City of Plymouth Planning Commission

Regular Meeting Agenda

Wednesday, March 13, 2024 – 7:00 p.m.
City Hall & Online Zoom Webinar

**Special Land Use and
Site Plan Review
For
Plymouth, Michigan**

SHEET NO:
L-1

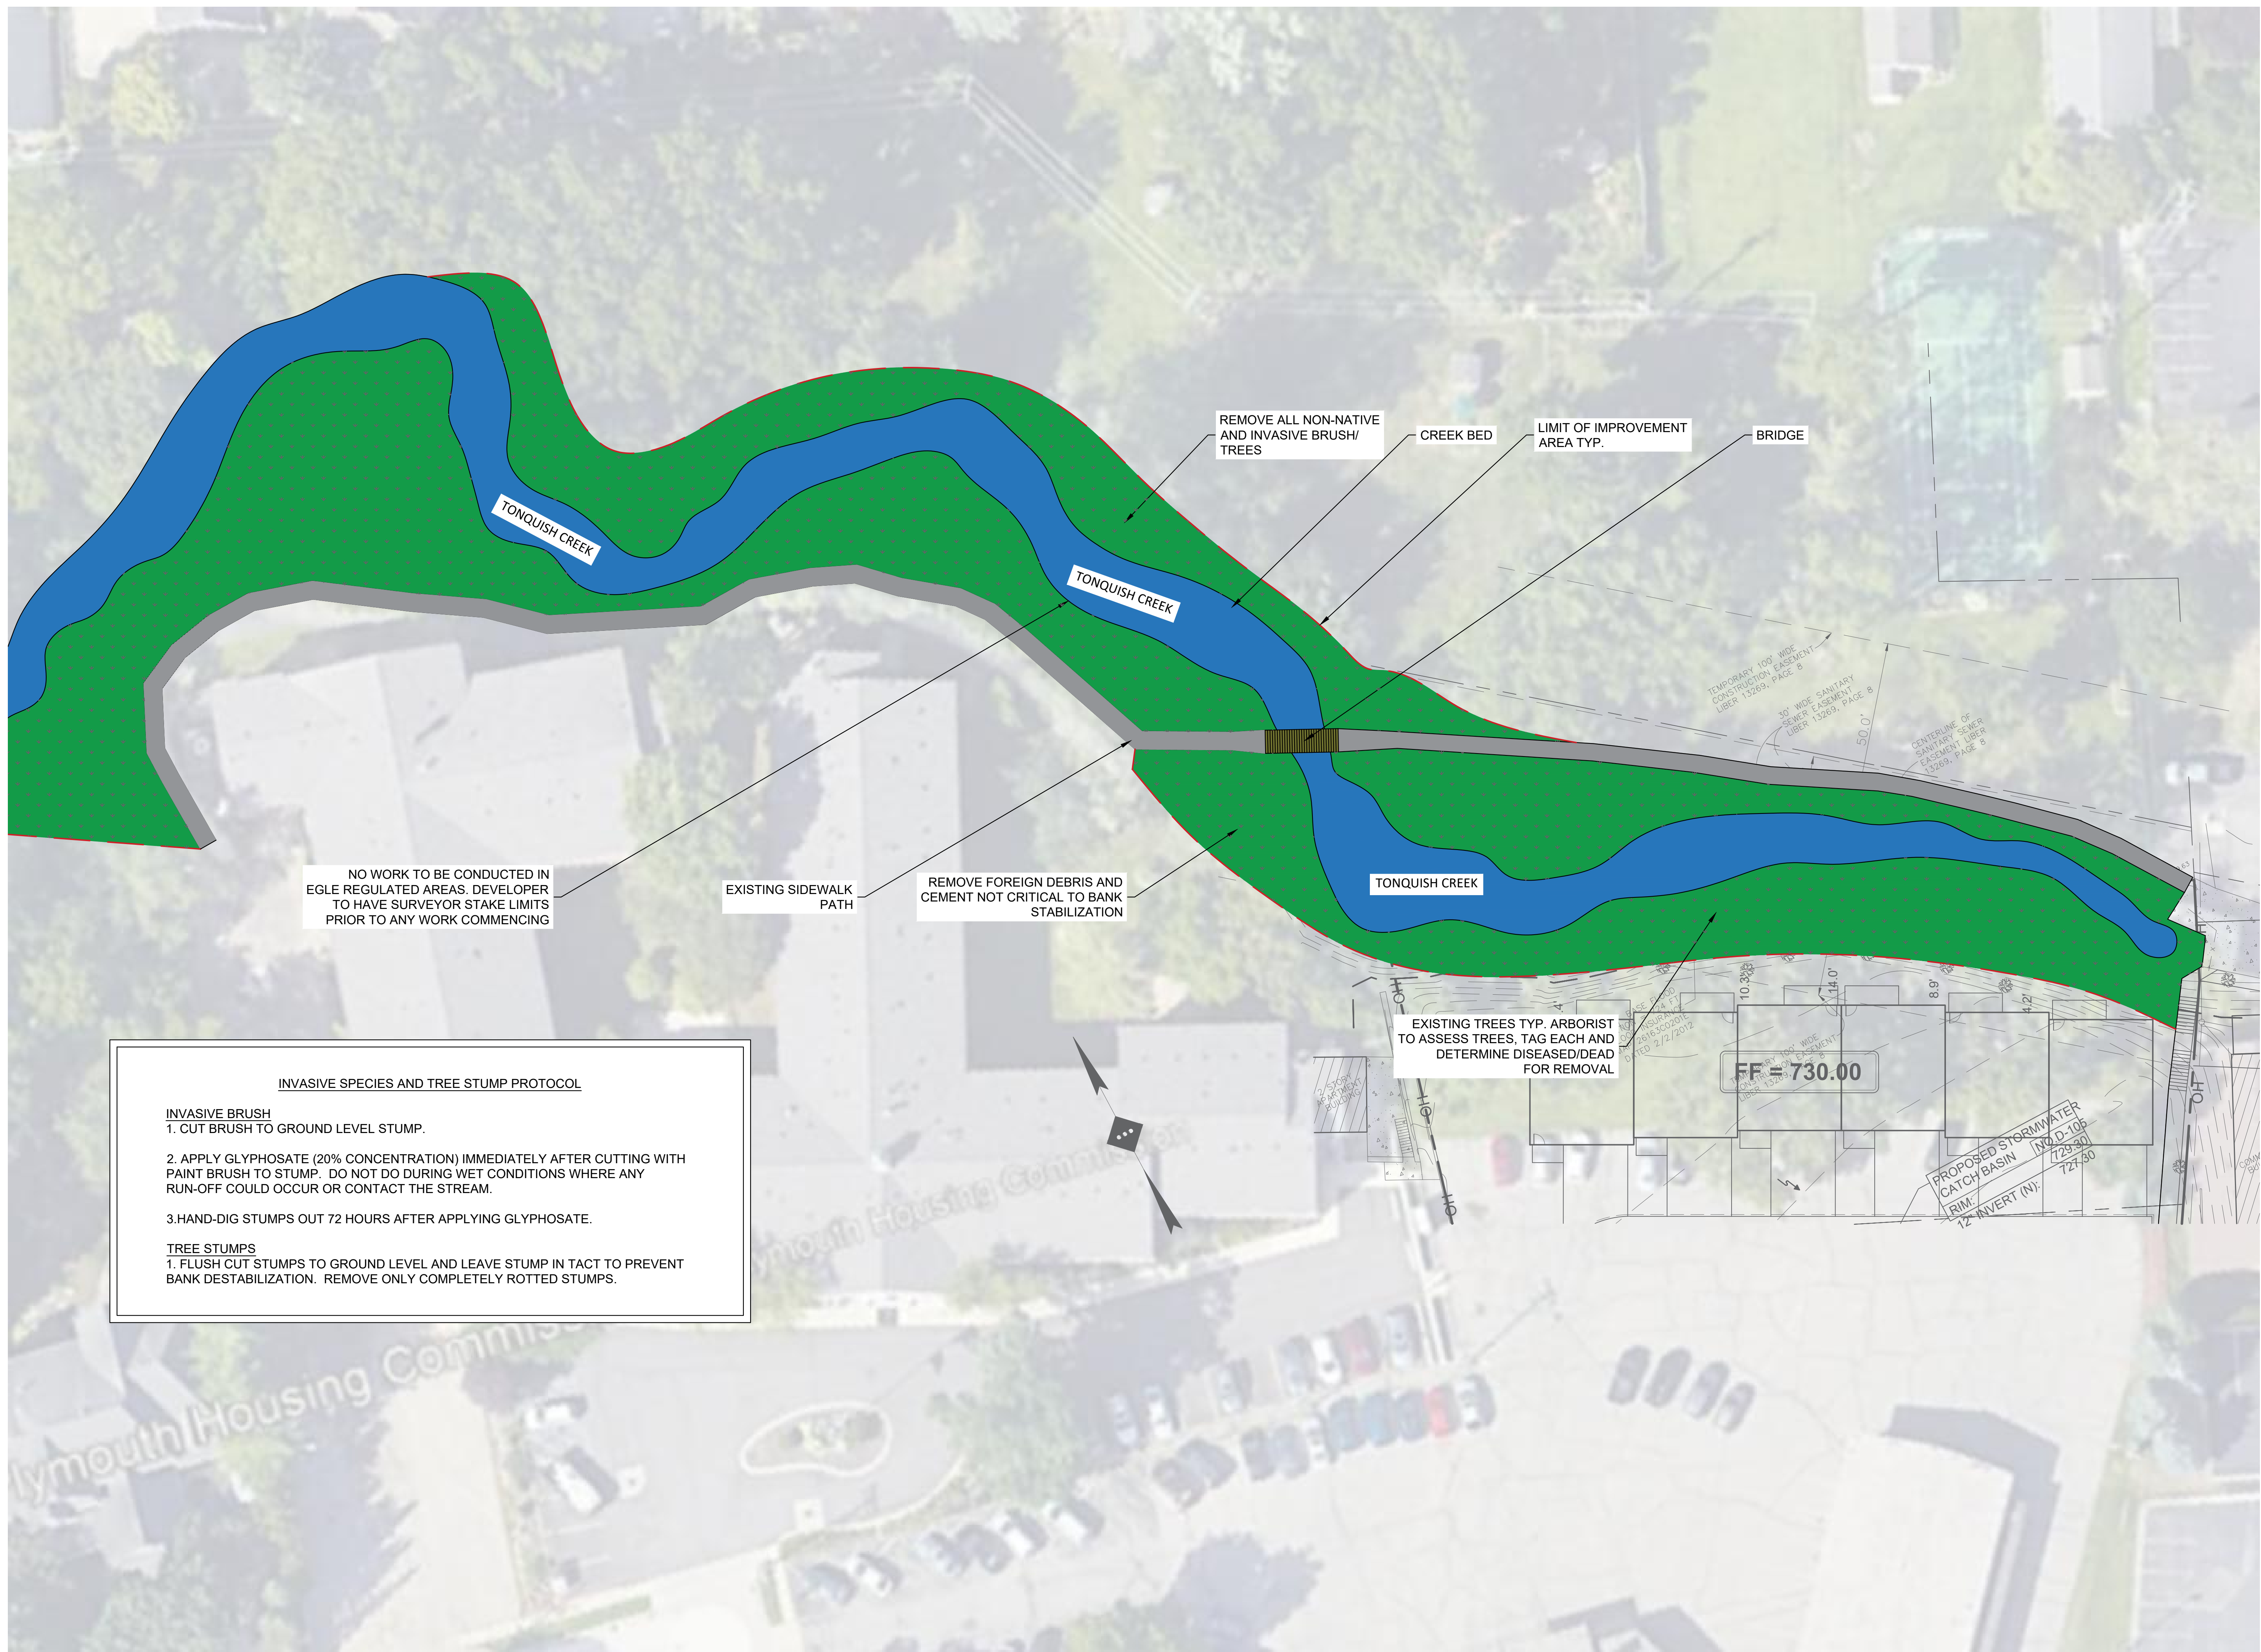
- Sheet L-1 notes state that the roots of invasive shrub should be dug out. This is contrary to the Restoration Plan that indicates that these roots should be retained to hold the streambank in place. This plan should be prepared by an ecological professional with demonstrated experience in streambank restoration.

SHEET NO:
L-2

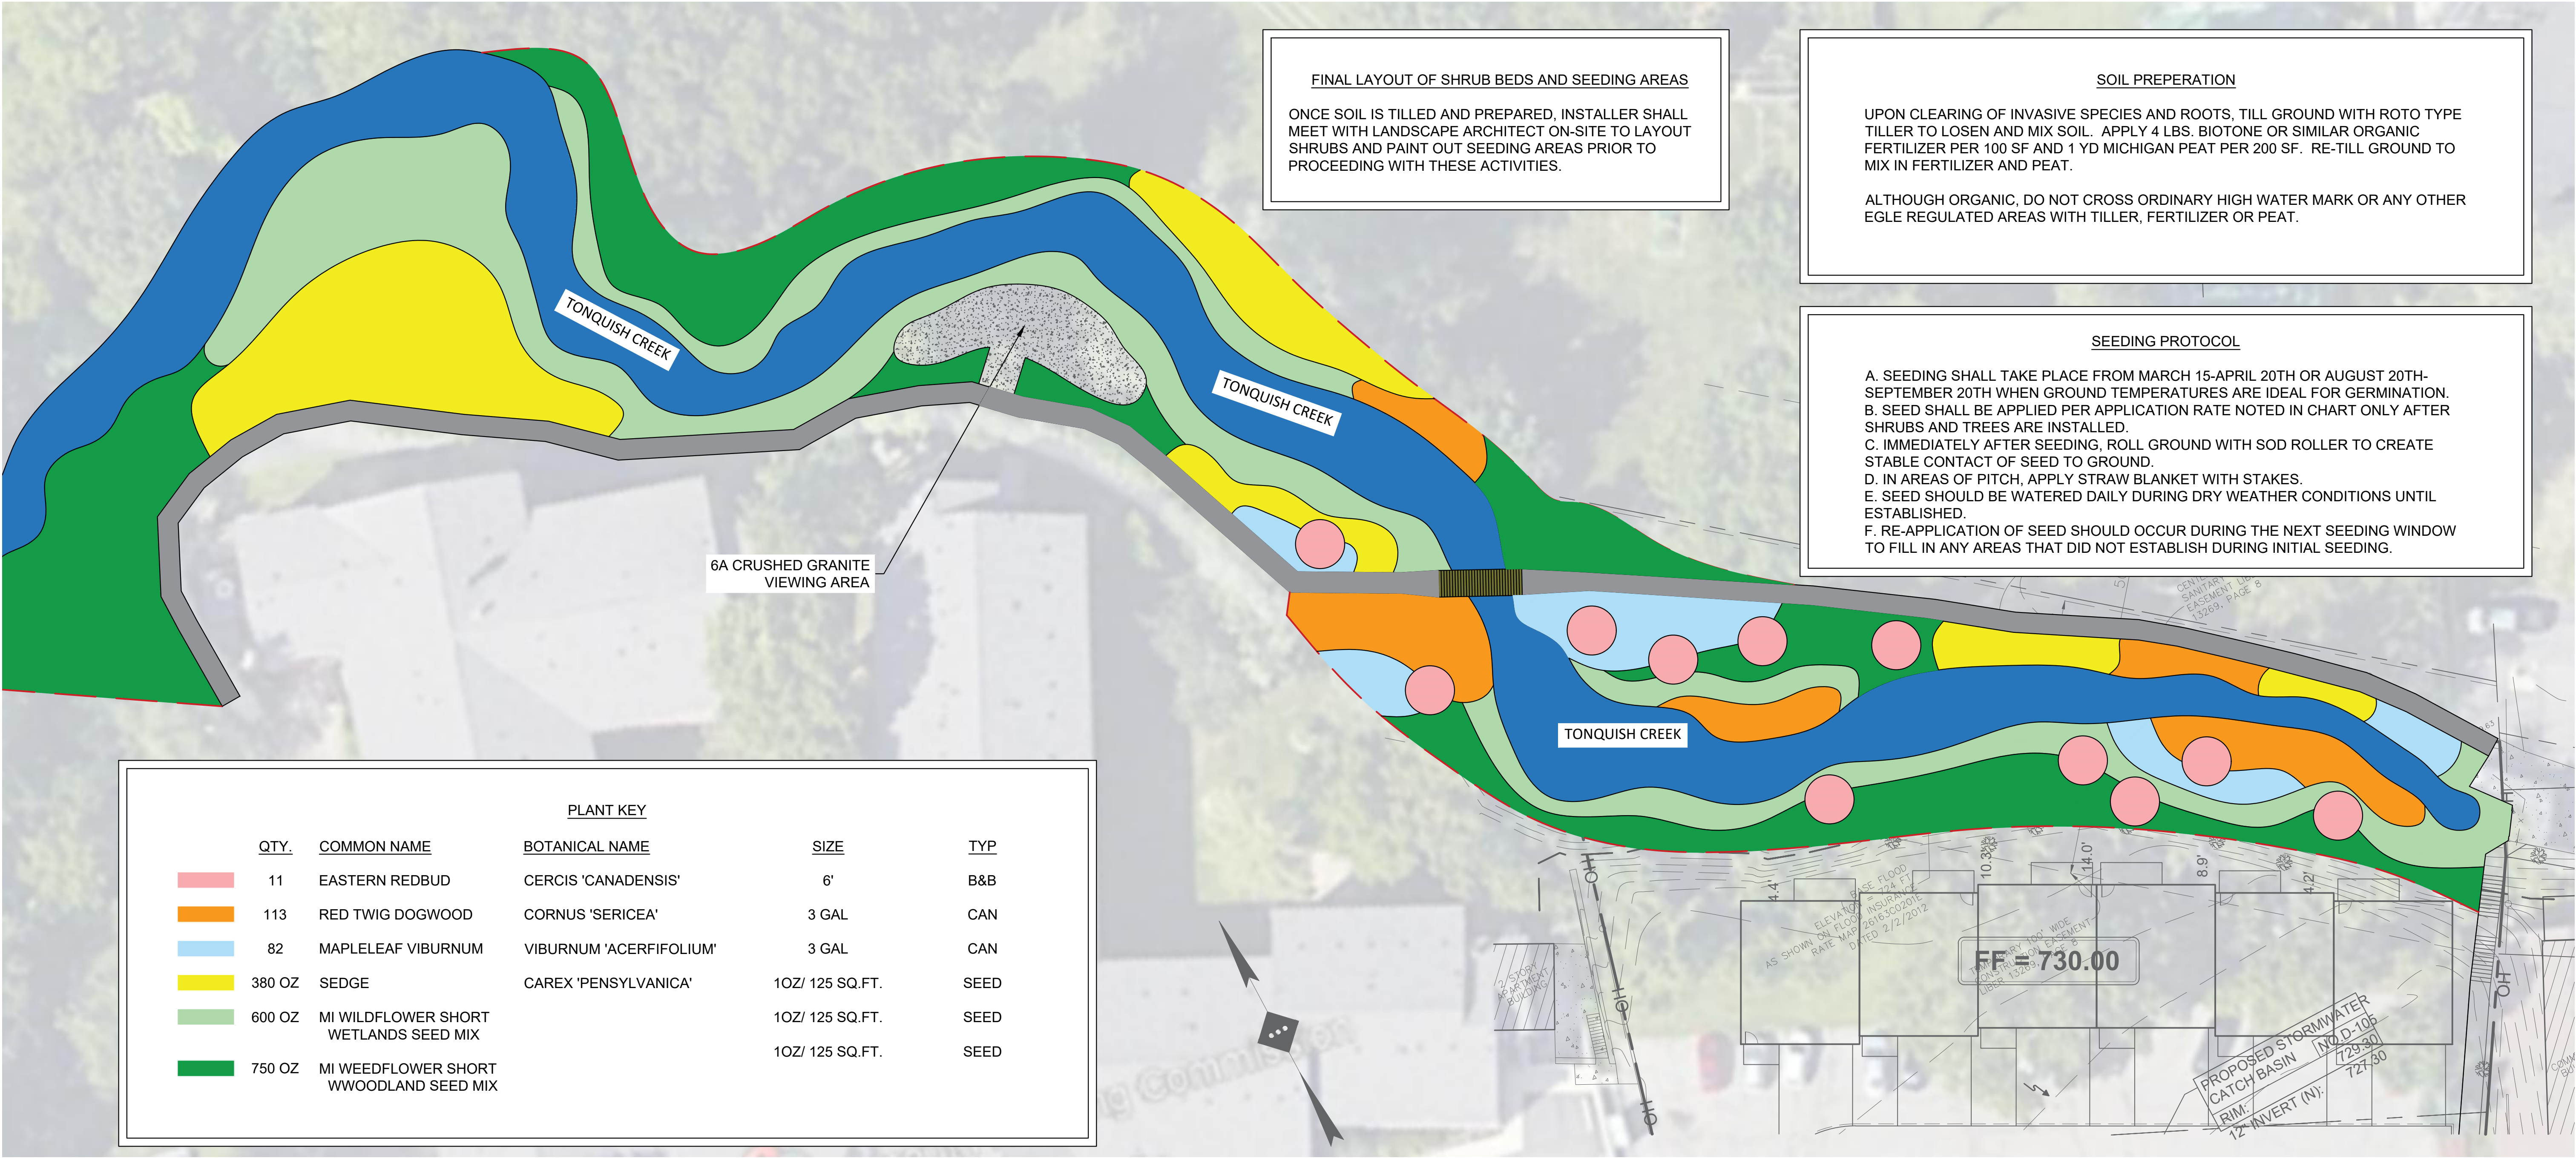
- Sheet L-2 calls for planting landscape-sized shrubs right next to the flowing water. Typically, stream bank restoration is done with “live stakes,” which are woody plant cuttings inserted into the streambank so that they root into, and protect, the streambank slopes. This plan should be prepared by an ecological professional with demonstrated experience in streambank restoration.

- vii. **Pocket Park along the Creek.** The narrative describes a patio area with some bench seating installed along the southern side of Tonquish Creek along the paved trail behind Tonquish Creek Manor. Sheet L-2 shows a crushed-gravel area next to the creek, about 70 feet from existing benches and 100 feet from the wooden bridge, which provides a view of the creek. The proposed gravel area is approximately 600 s.f. in size. Installation of the gravel area will require tree removal, which could threaten the stabilization of the stream bank.
